# **Report on “public consultation of Proposal for an implementation plan for new aFRR design and separated procurement of FCR and aFRR”**

Public Consultation held between 09/11/2018 – 05/12/2018

**Market Development**

20/12/2018

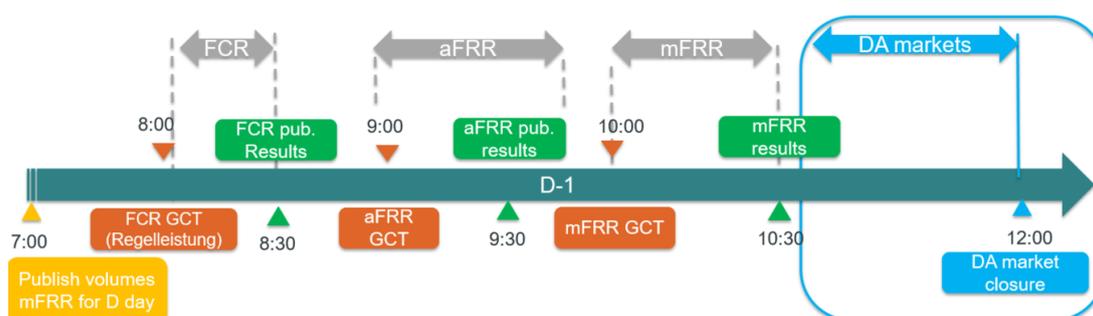
REstore therefore asks Elia to not only identify and document advantages of an interim solution, but also consider these costly, time-consuming and inefficient constraints in the full cost-benefit analysis of implementing a phased approach.

-> REstore asks Elia to consider the full cost-benefit analysis to assess whether implementing an interim solution is really needed regarding the procurement cycle of FCR, aFRR, and mFRR in 2020.

Based on the feedback of the stakeholders on this topic, Elia will organize the daily procurement at D-1 at 9h00 for aFRR, with publication of the results at the latest on 09h30, as indicated in the implementation plan and presented below.
